Register of Gas Installers of Ireland

Technical Bulletin

Glow-worm 'xi' range of boilers – Product modification and servicing reminder from Glow-worm

March 2012

Seal between burner door and main heat exchanger (new graphite seal illustrated).

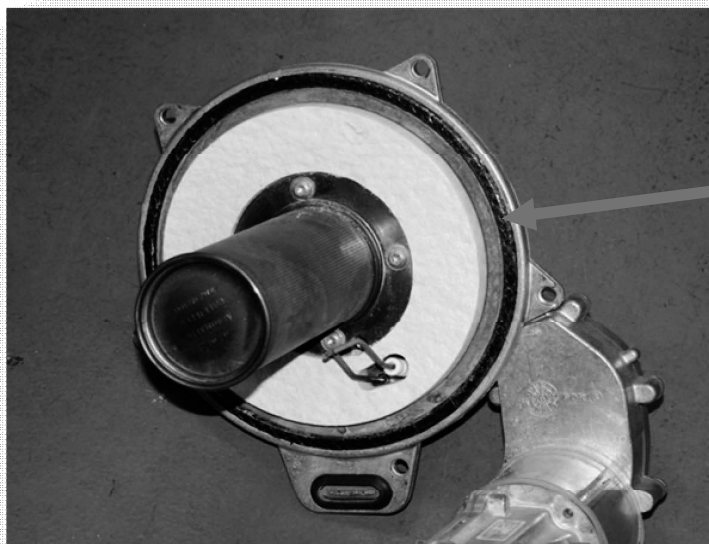
All of the above boilers produced **before** April 2006 were fitted with a silicon seal between the burner door and main heat exchanger, see illustration below.

From April 2006, a new graphite seal was introduced which has the following significant benefits:

- The graphite seal does not need periodic replacement at the time of normal annual servicing unlike the original silicon seal;
- The new graphite seal is also designed such that it is not necessary to remove the burner module during annual servicing. The burner module would only need to be removed and inspected should either a combustion analysis or visual inspection of the flame picture indicate the appliance is outside of specification.

Important: If the burner door is removed for any reason a new graphite seal must always be fitted.

In light of the significant benefits of the new graphite seal, Glow-worm are strongly recommending to all Registered Gas Installers to replace the existing silicon seal with a new graphite seal at the time of normal annual servicing on any of the above boilers. Full instructions for replacement of the seal are included in the seal packs.
